ISO/IEC/  
IEEE  
8802-11

AMENDMENT 4  
2020-08

**AMENDMENT 4: Enhancements for  
transit links within bridged network**

**IEEE Std 802.11ak™-2018**

Figure 5-1—MAC data plane architecture

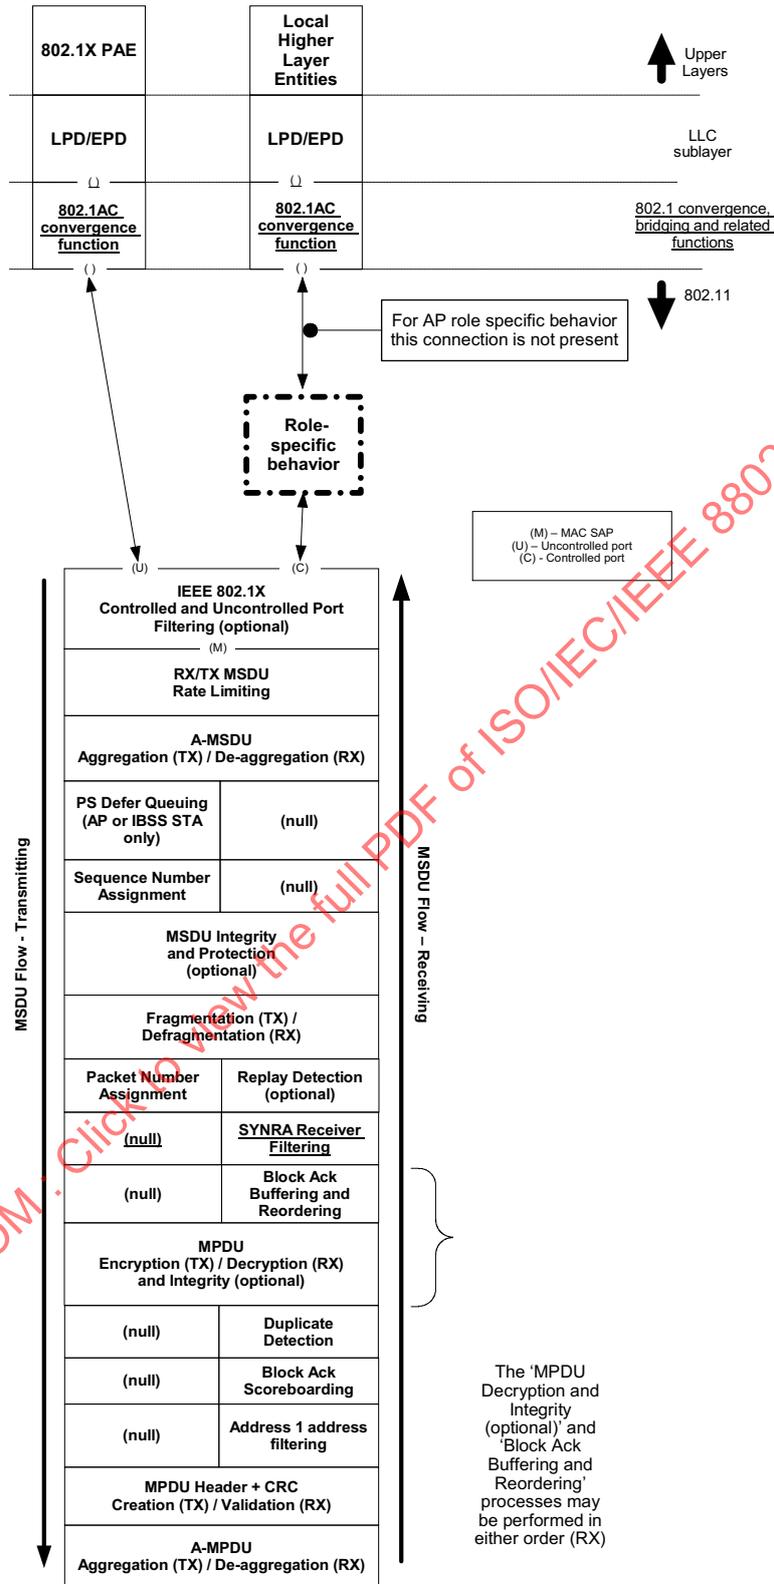
*Change Figure 5-1 and Figure 5-2 as shown:*

Figure 9-504—DMG STA Capability Information field format

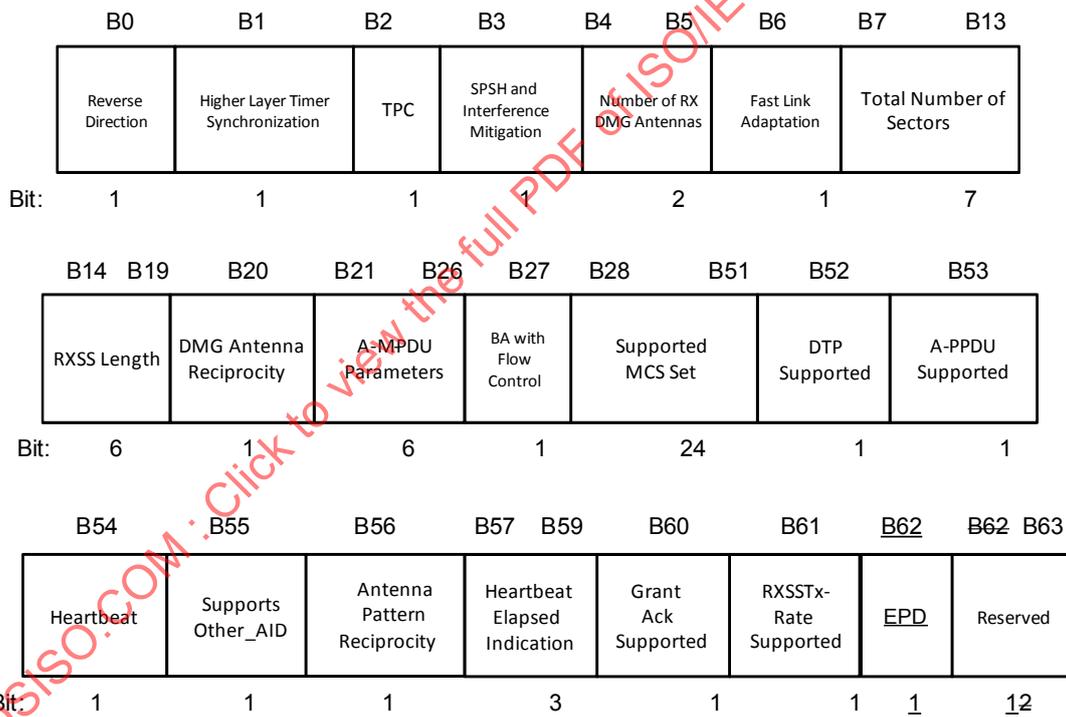
Change Figure 9-504 as follows:

Insert the following paragraph at the end of 9.4.2.128.2:
